ADDENDUM #2

Reference: Building 5100 – Camp Williams
Utah National Guard – Riverton, Utah
DFCM Project No. 07332480

addendum
2

SUPPLEMENTAL ELECTRICAL DRAWING

SE1.1

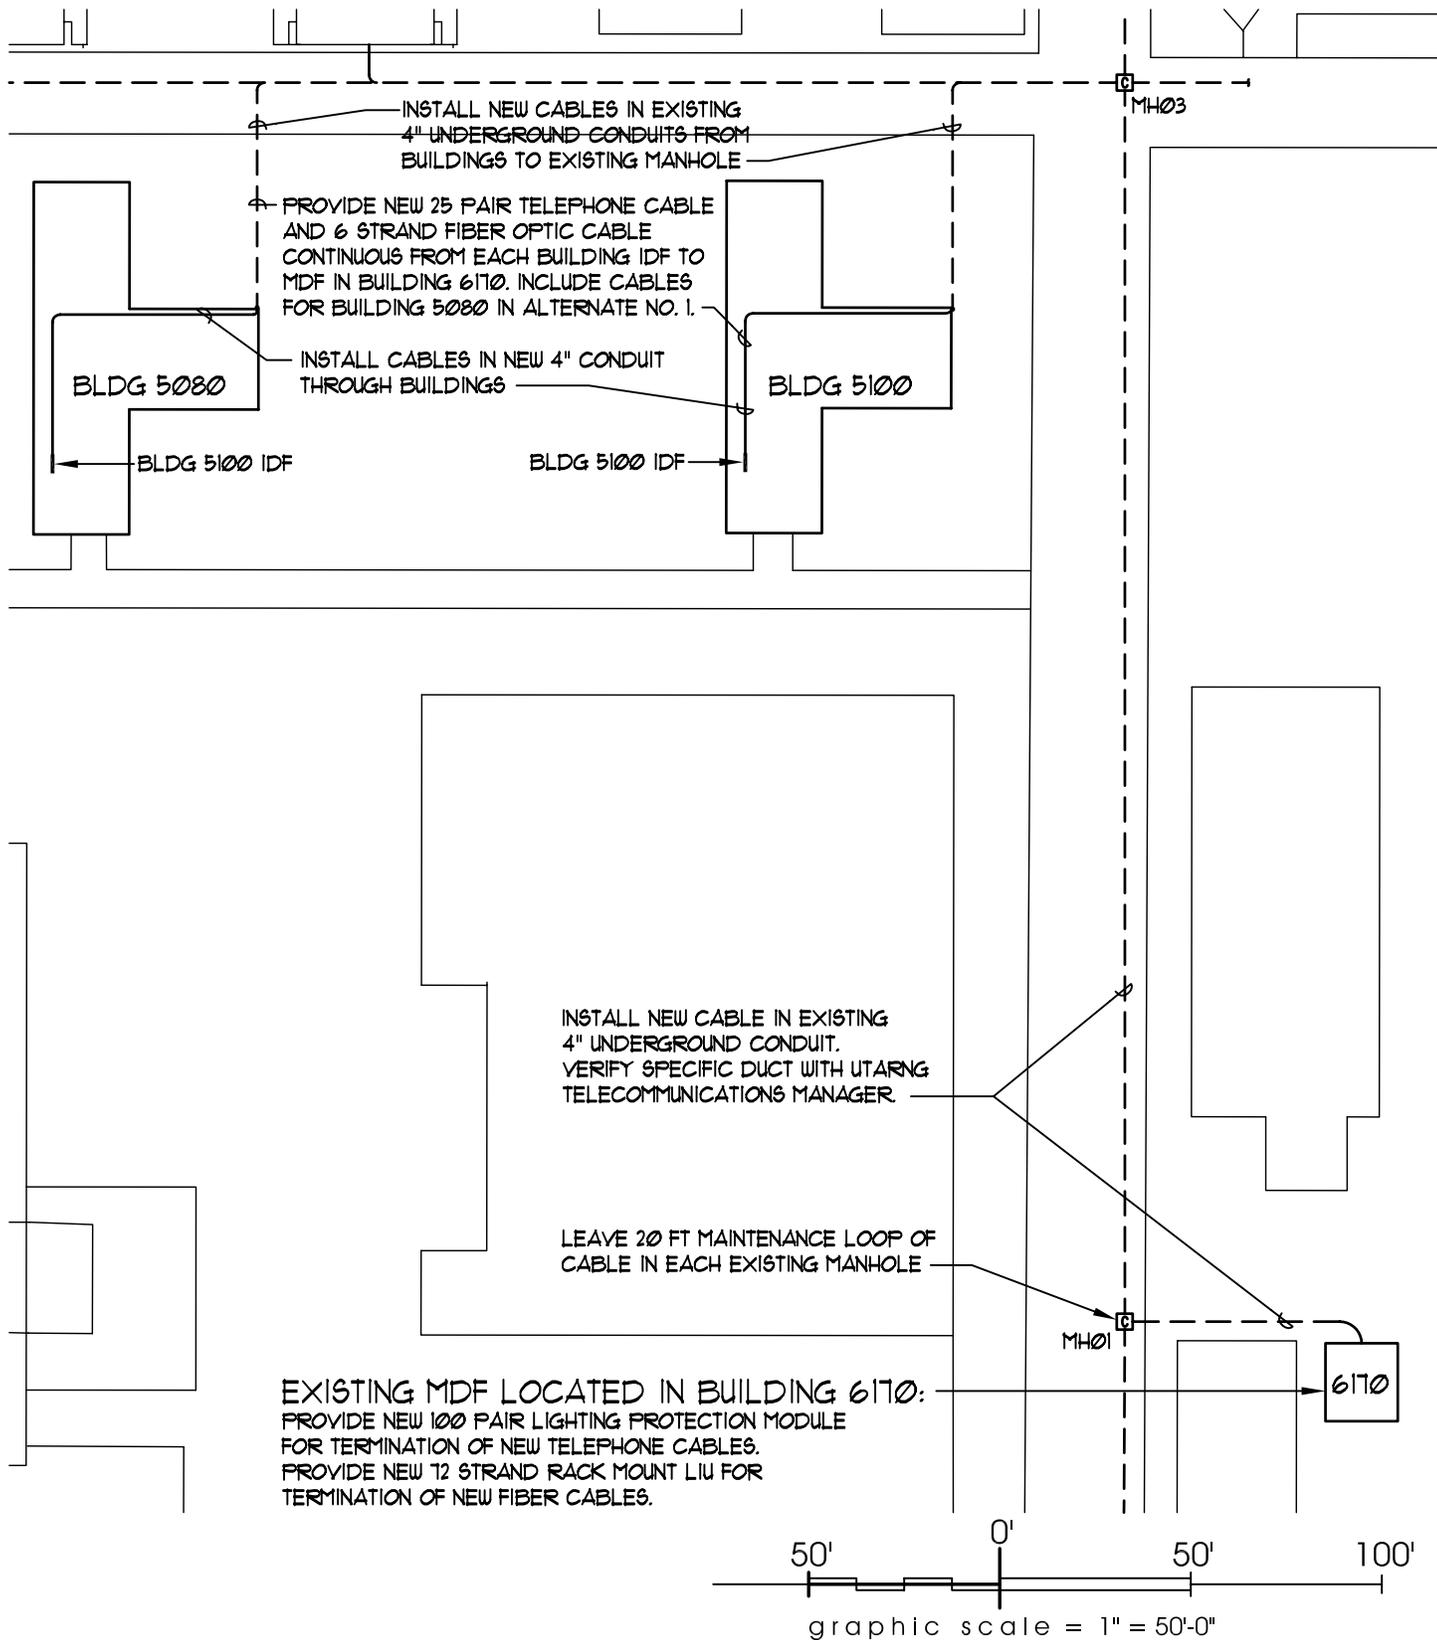
2. Electrical Site Plan A5/ES101. Refer to partial revised electrical site plan on Supplemental Electrical Drawing SE1.1 for cable requirements from the Main Distribution Frame in Building 6170 to new Intermediate Distribution Frames in Buildings 5080 and 5100. Include cables for Building 5080 in Alternate No. 1.
